| P/LR DATE                                                                             |  |      | P/LR NAME |                                                                                                                                        | (LPS-510A(AK1)-2L-SCH-2024) 7750 00 Doc# 1 |  |

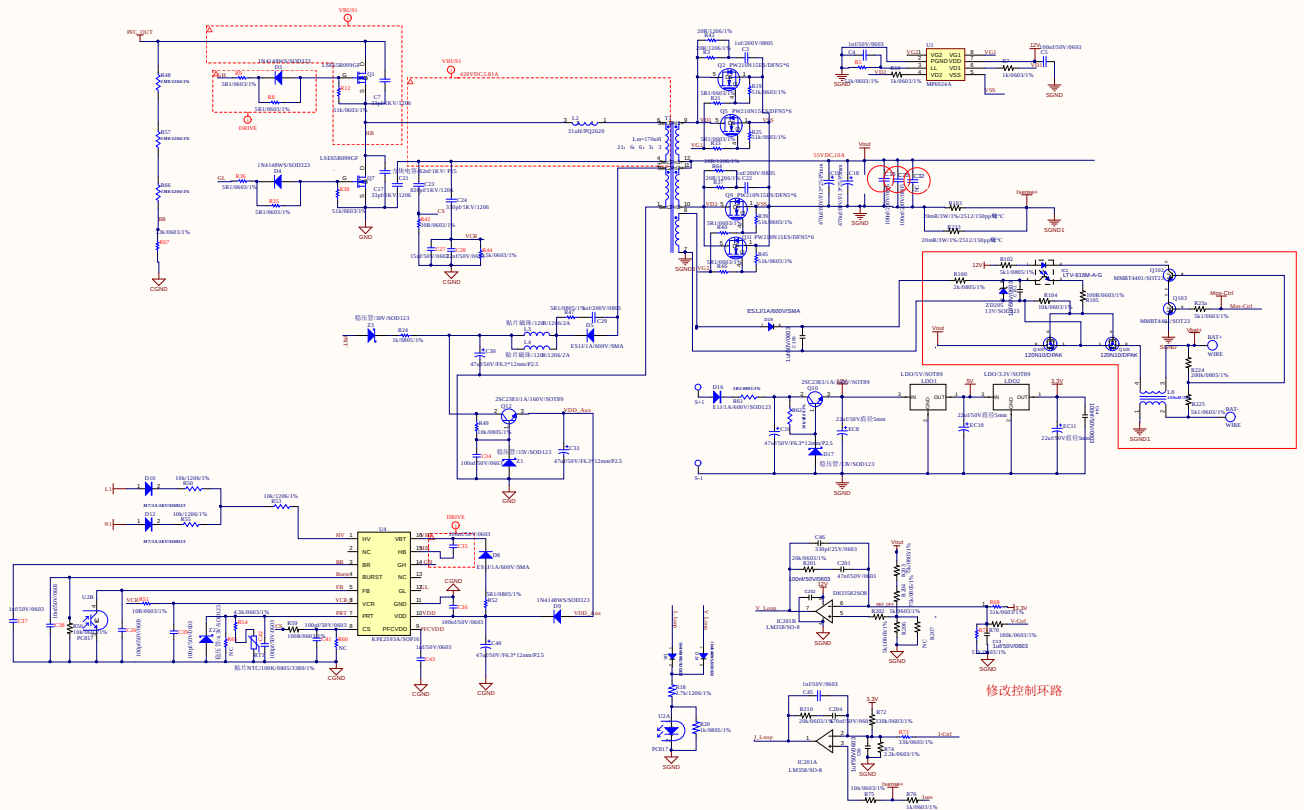
1. 放大器件供电用12V
2. 0x30读、写时15V稳压电路去两个二极管保护，VDD管脚电压仅为13.5V
3. 电压电流环路改变
4. FB管脚电容加大到1nF
5. PFCFB与RRA分压电路拆解
6. PFC改为10uF 100V
7. 电源管理电路的地？
8. 12V供电支路电容改为100uF
